February 1, 2023

Lenoir County Administration Building – Interior Renovation

ADDENDUM NO. 2

Sheet ED1.1

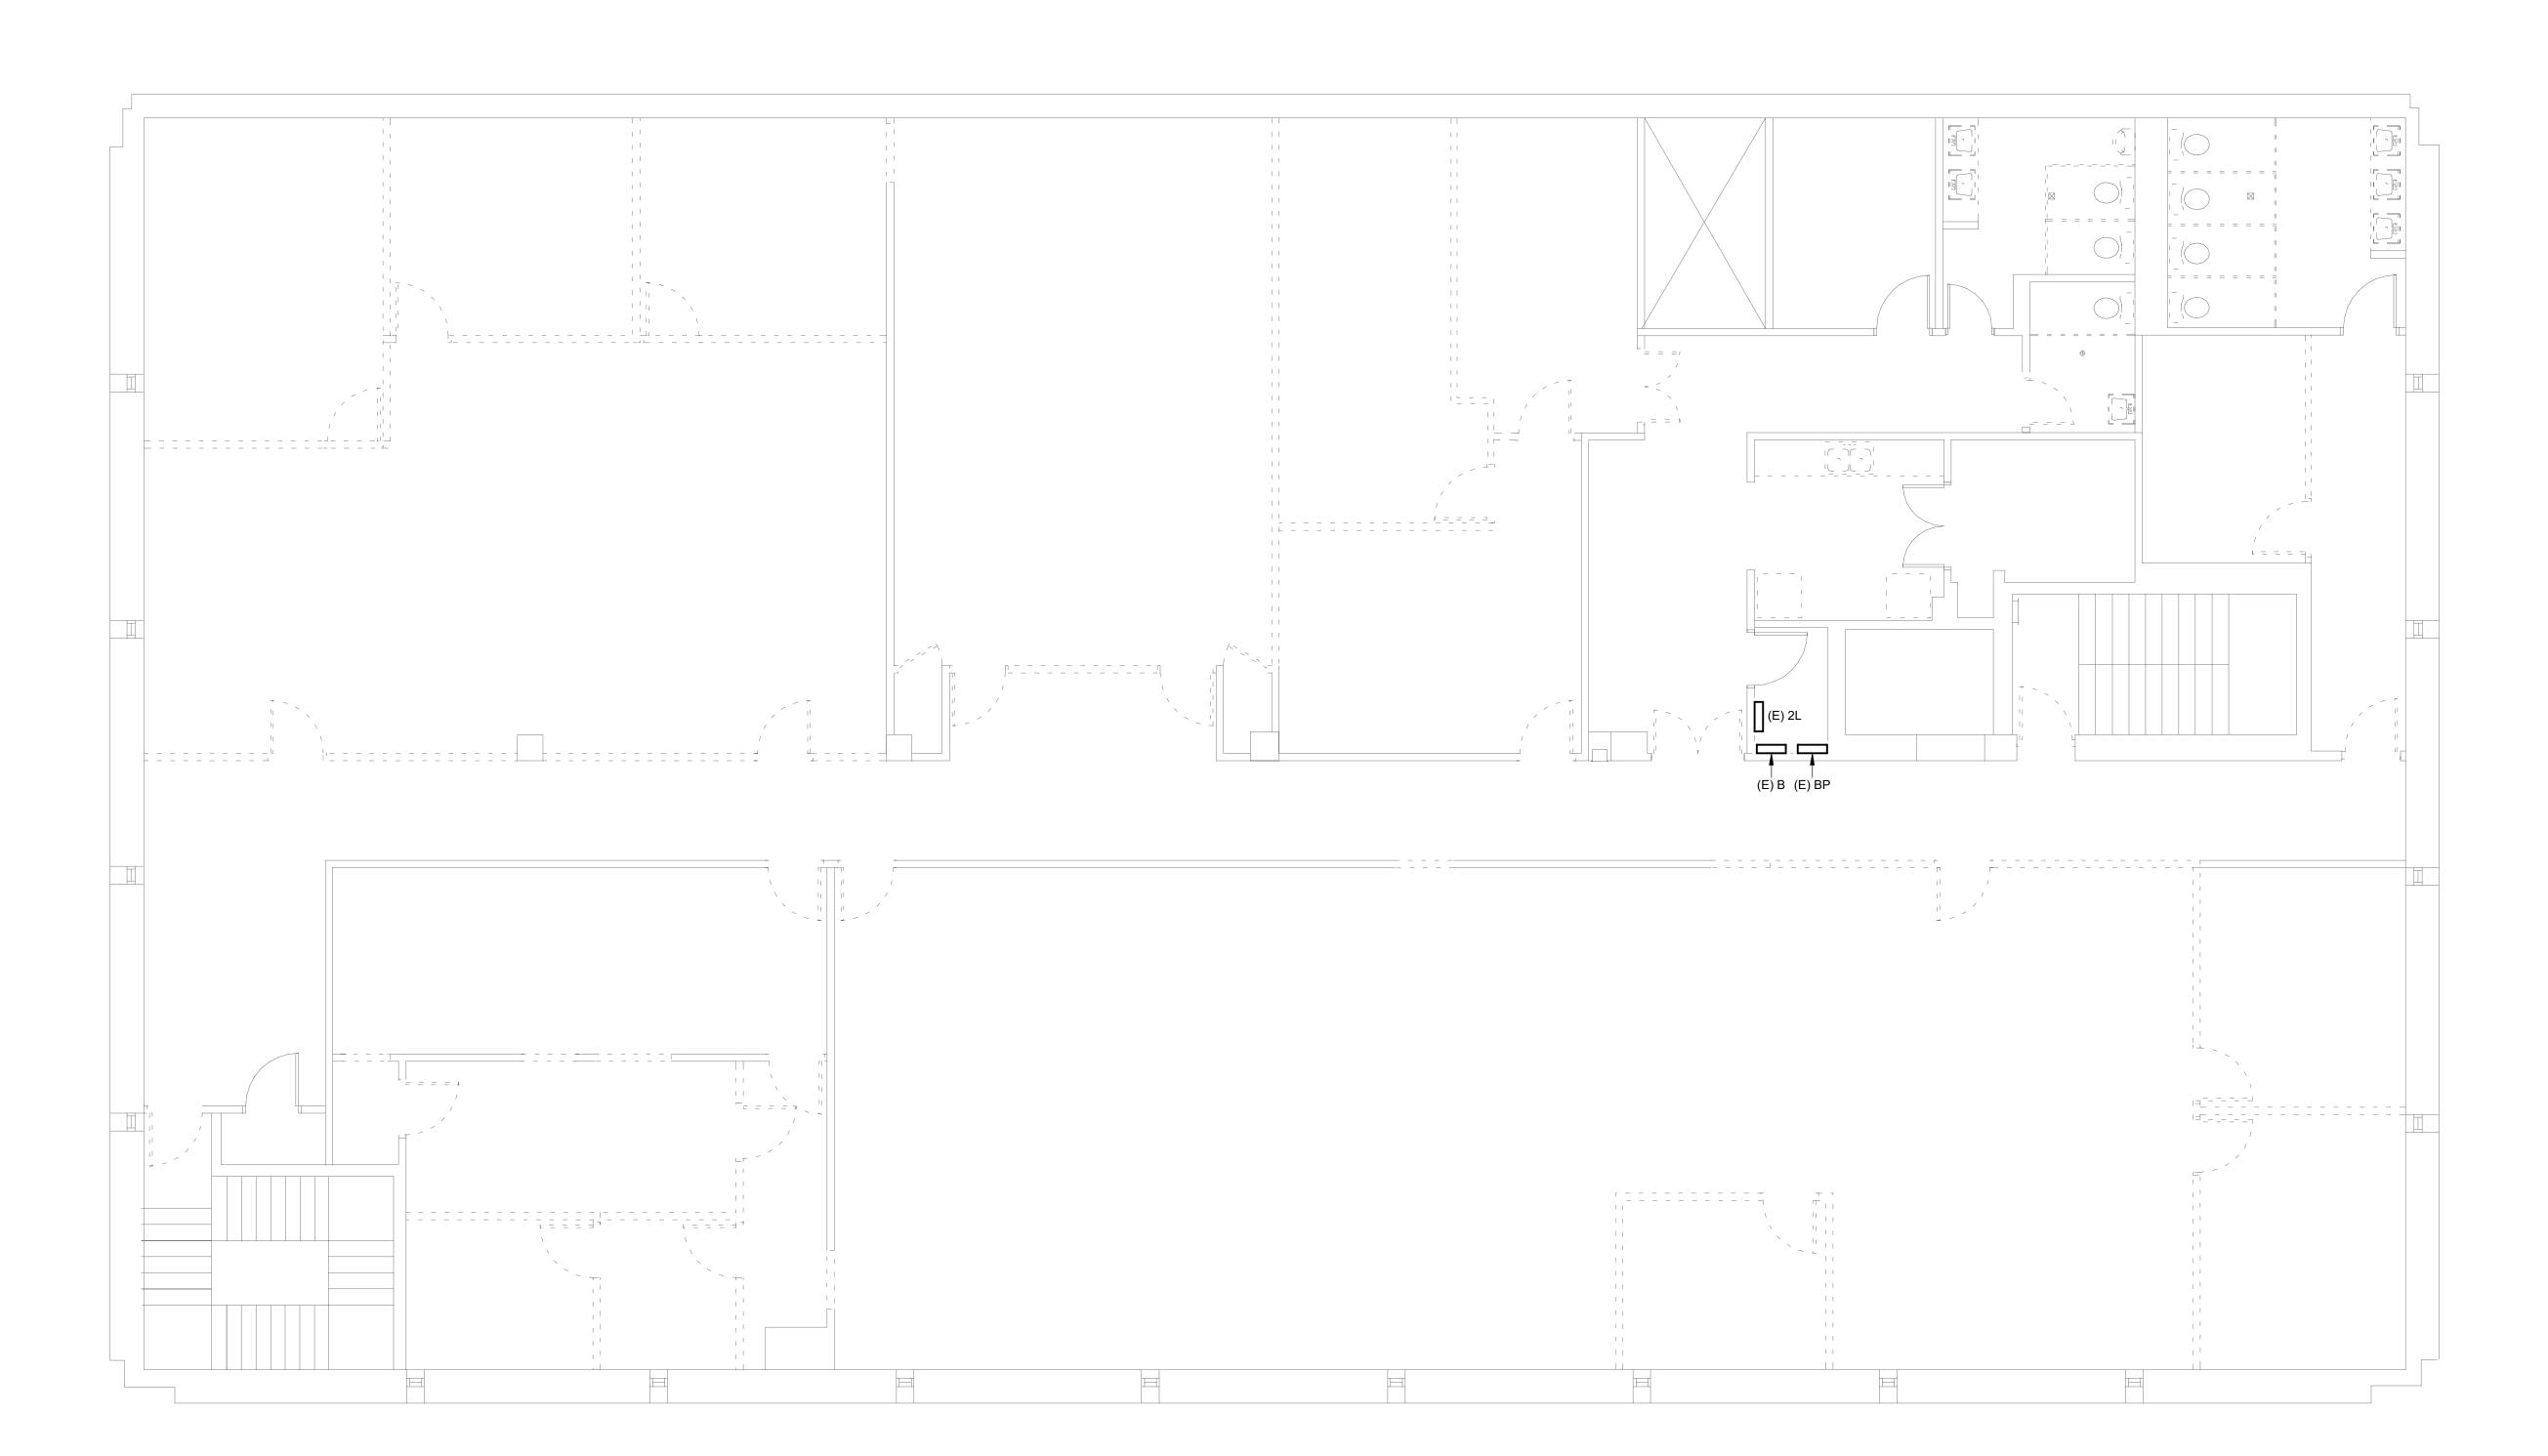
Added notes regarding demolition of electrical connection to existing mechanical equipment.

Sheet ED1.3

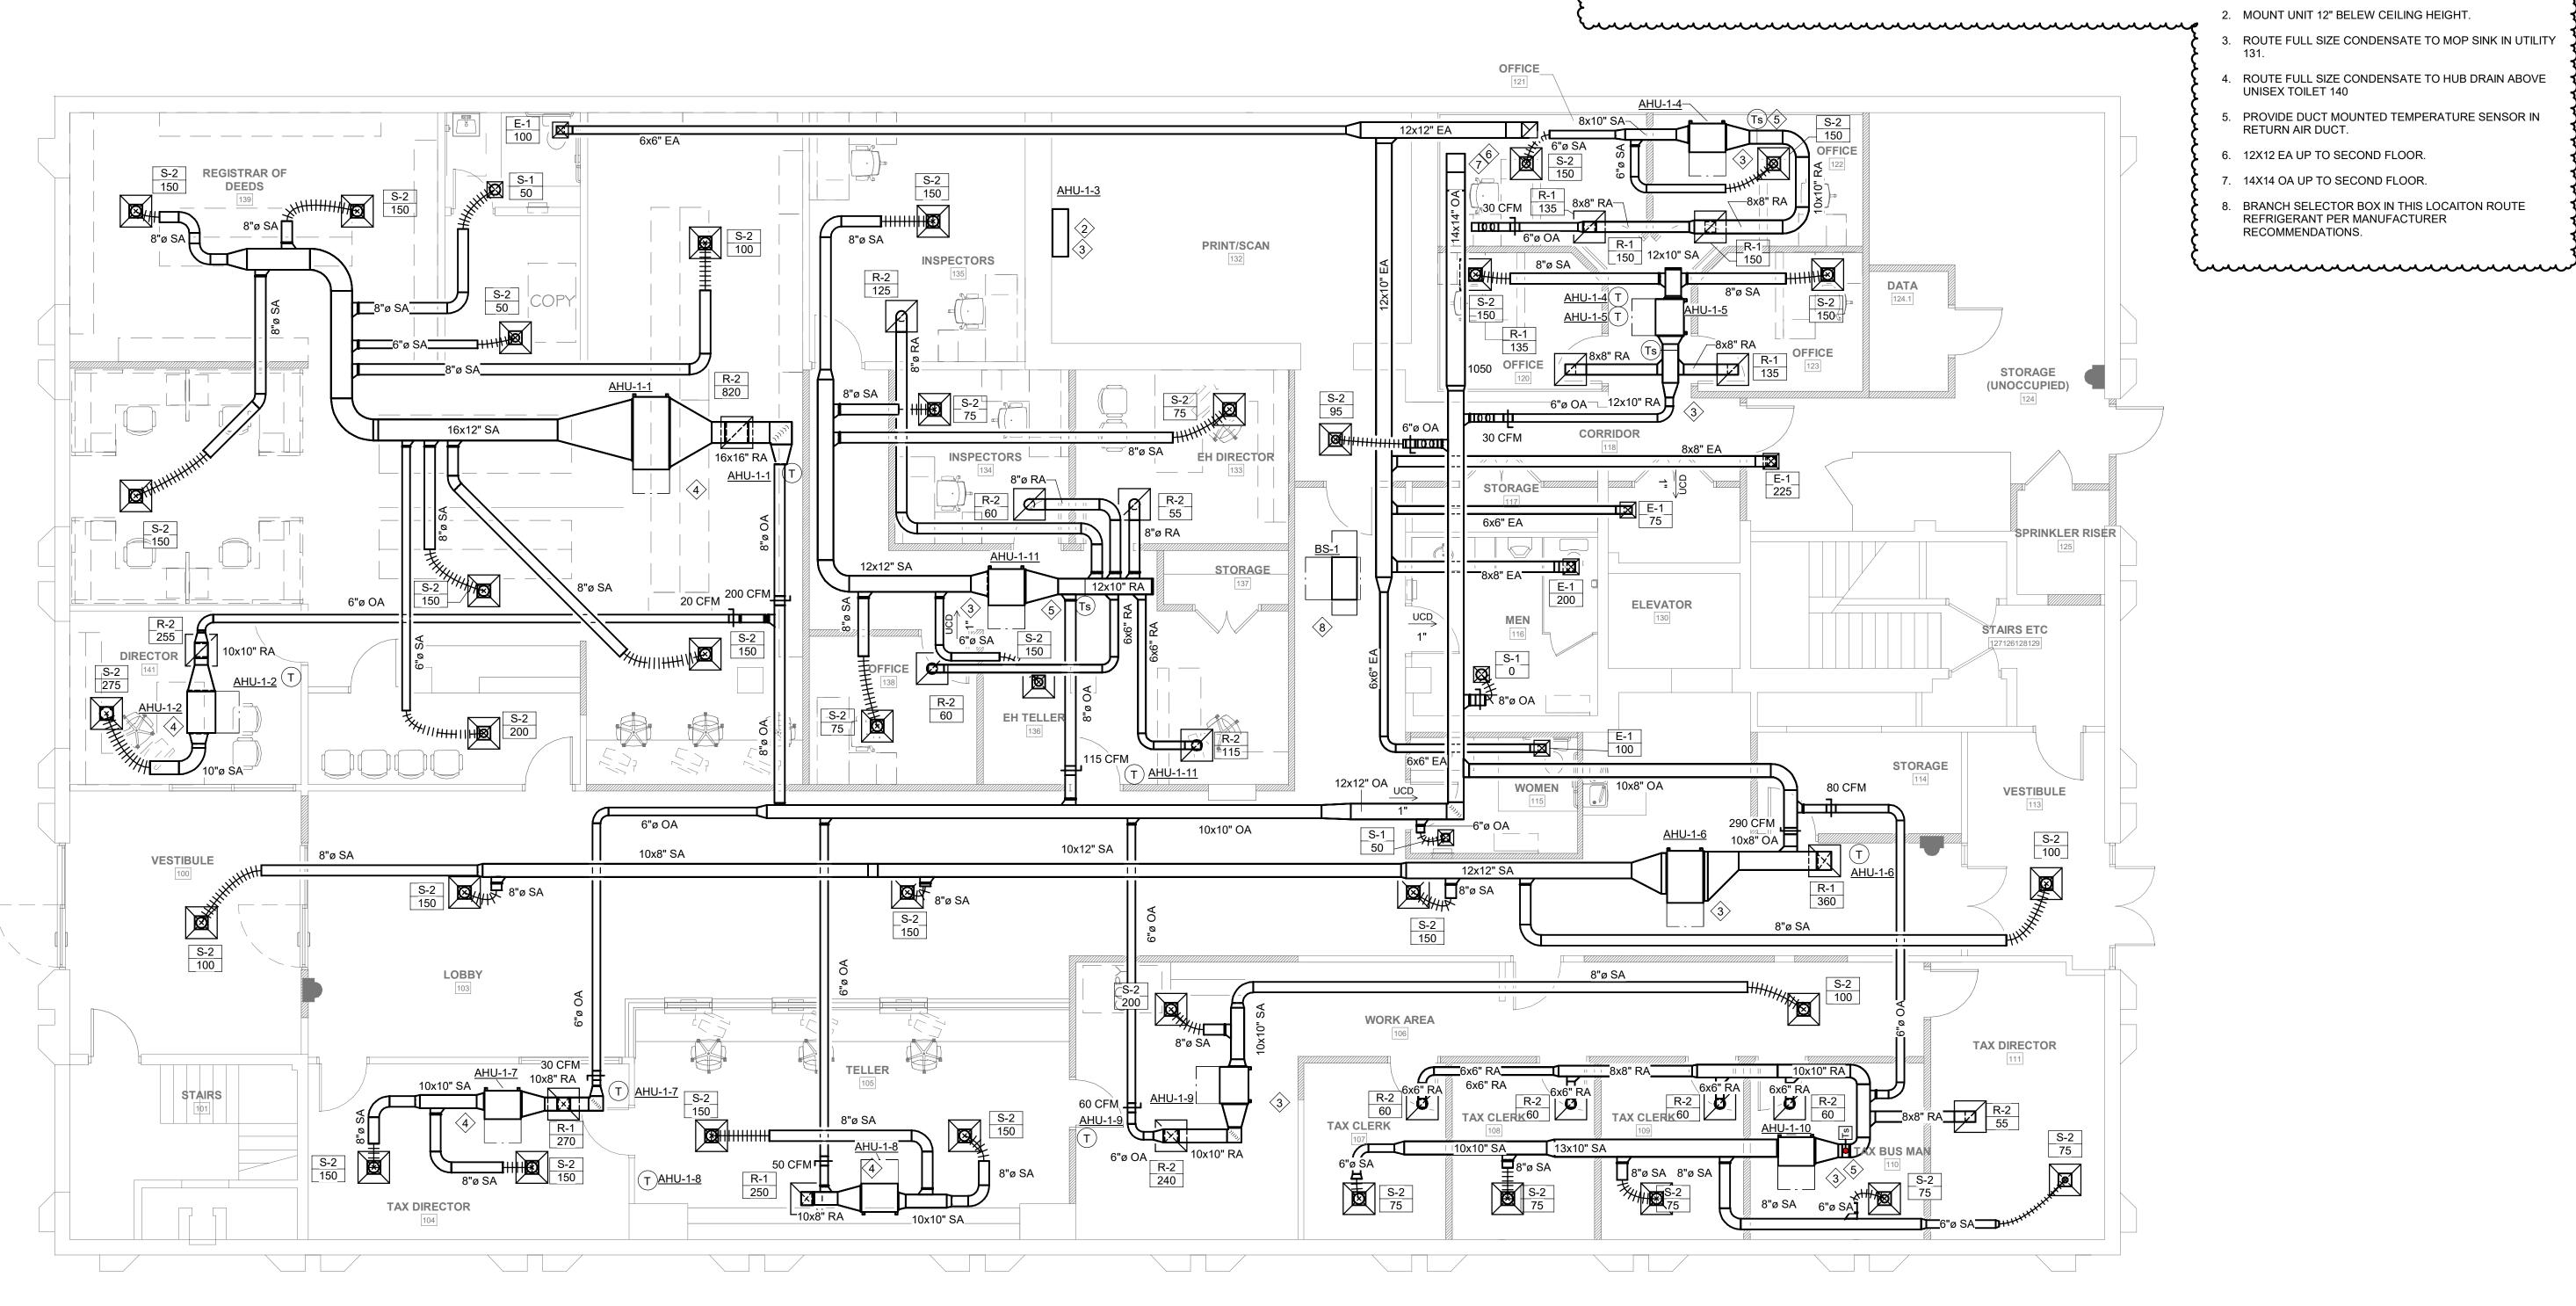
Added sheet for electrical roof demolition plan.

Sheet M1.1

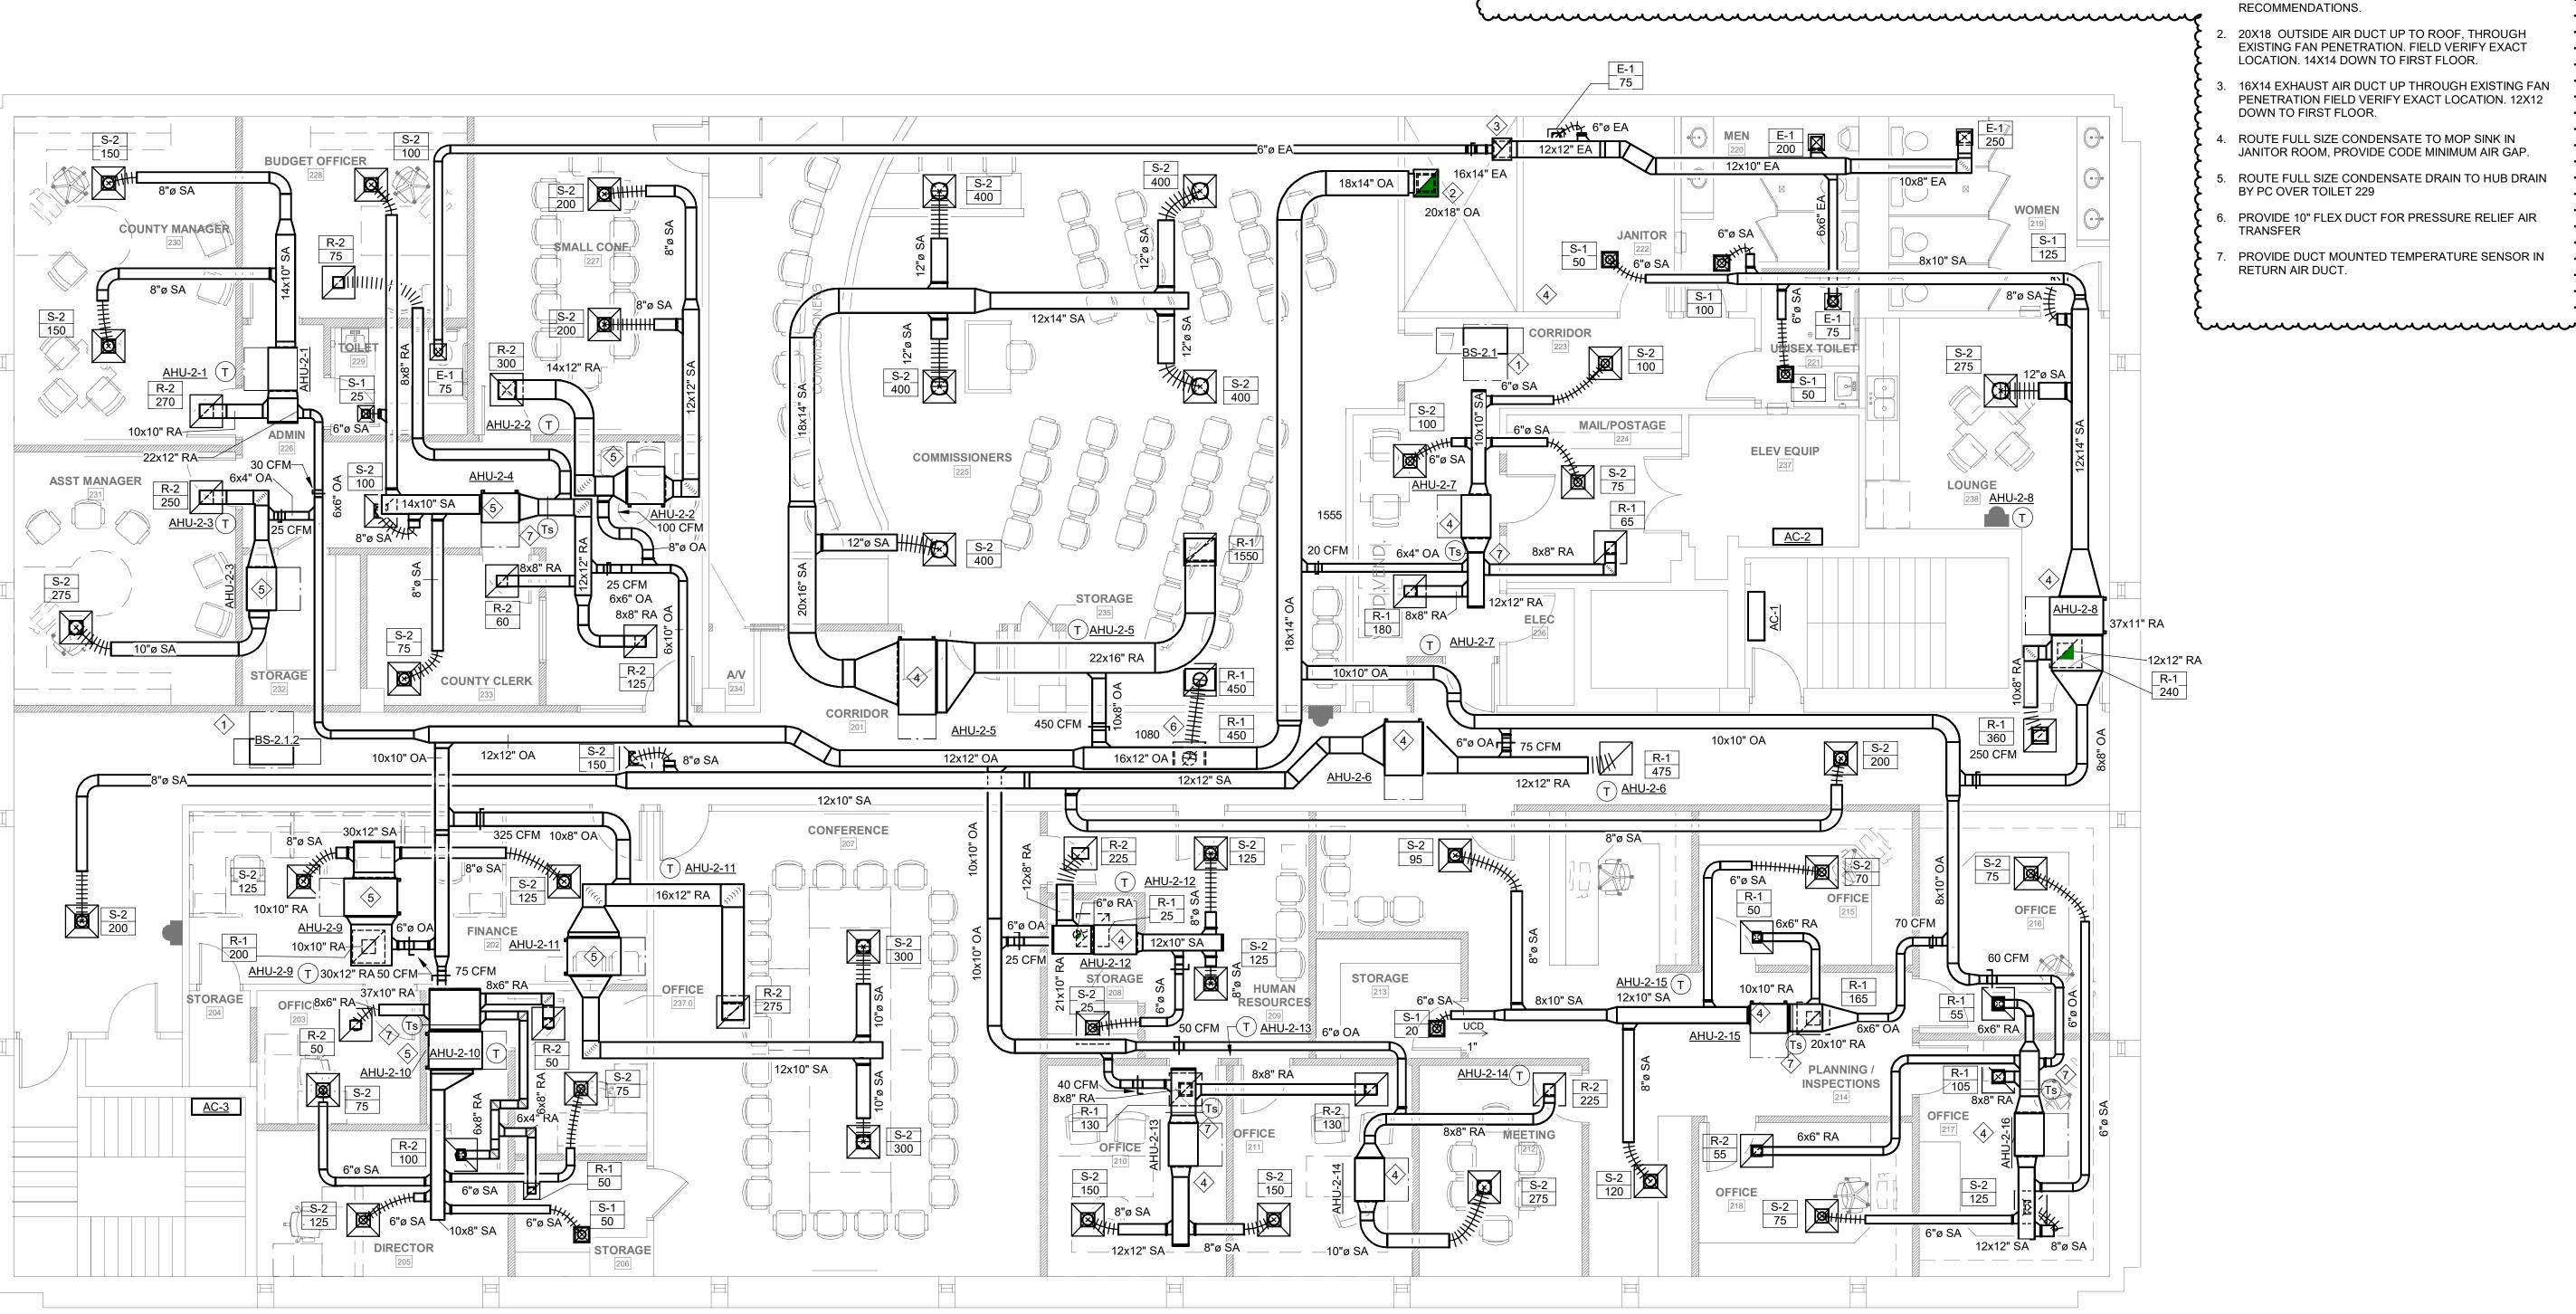
Removed demolition notes from sheet.
